TAL-CO SUPPLEMENTAL INSTRUCTION #76			
EXIT CORRIDORS - FIREWALL SEPARATION DETAIL			
Project Name:	RW TOMLINSON - NEW HEAD OFFICE		
Project Location:	100 CitiGate Drive, Ottawa, Ontario		
ARCH. SI #:	ASK 129	Issued By:	Farah Bano
STRUC. SI #:	N/A	Date Issued:	December 14, 2017
MECH. SI #:	N/A	Revision #:	N/A
ELEC. SI #:	N/A	Revision Date:	N/A

TITLE: EXIT CORRIDORS - FIREWALL SEPARATION DETAIL

ASK 129 (Dated 11/21/2017)

PROJECT:
TOMLINSON NEW BUILDING

2
A124

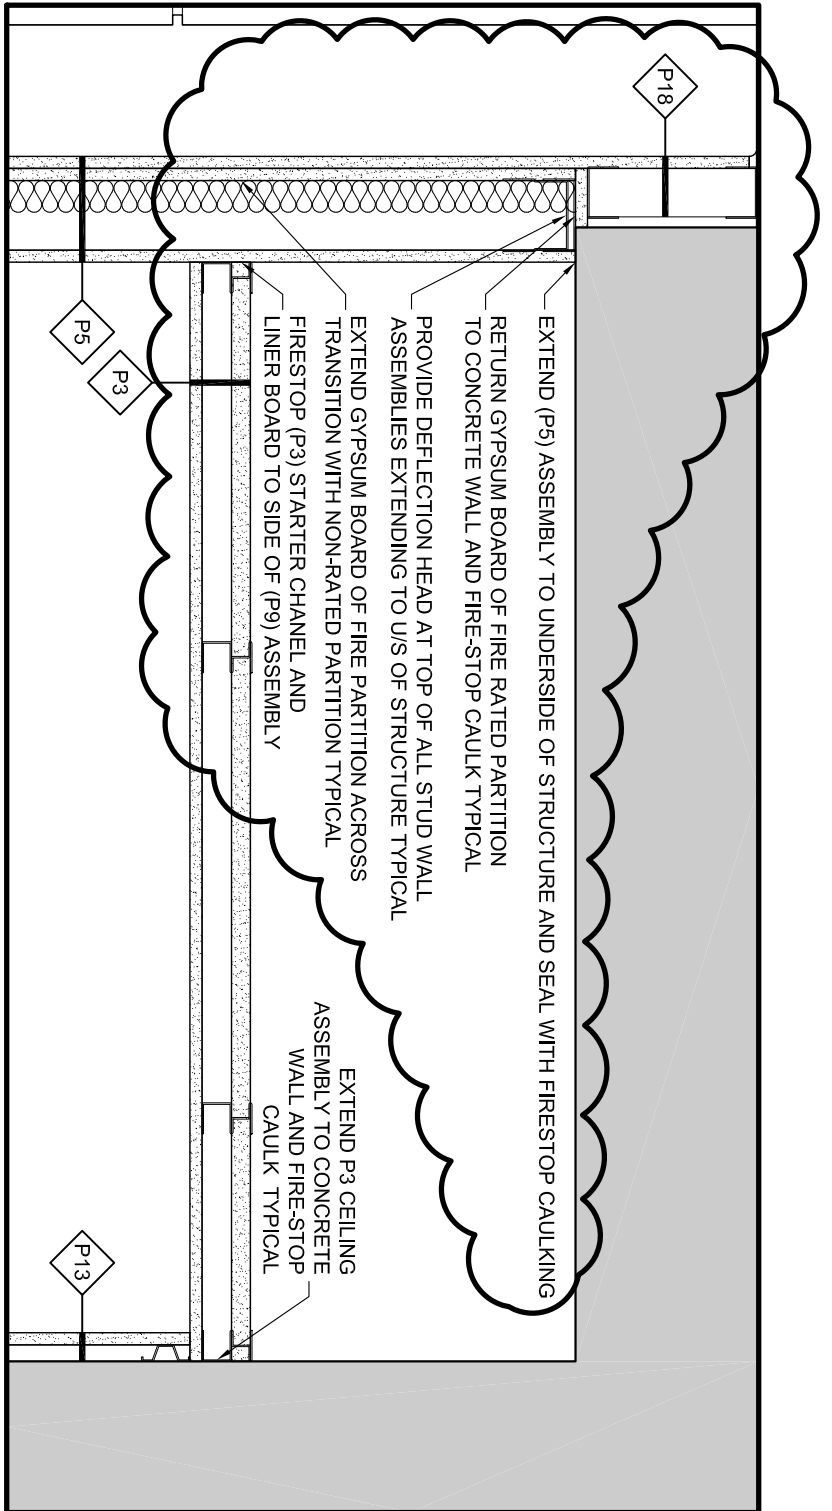
Extend Exit Corridor fire-rated wall assembly to underside of structure as per attached detail. Detail 2/A124 identified on architectural elevation drawing 2/A302.

Requested by Building Inspector to maintain integrity of fire exits.
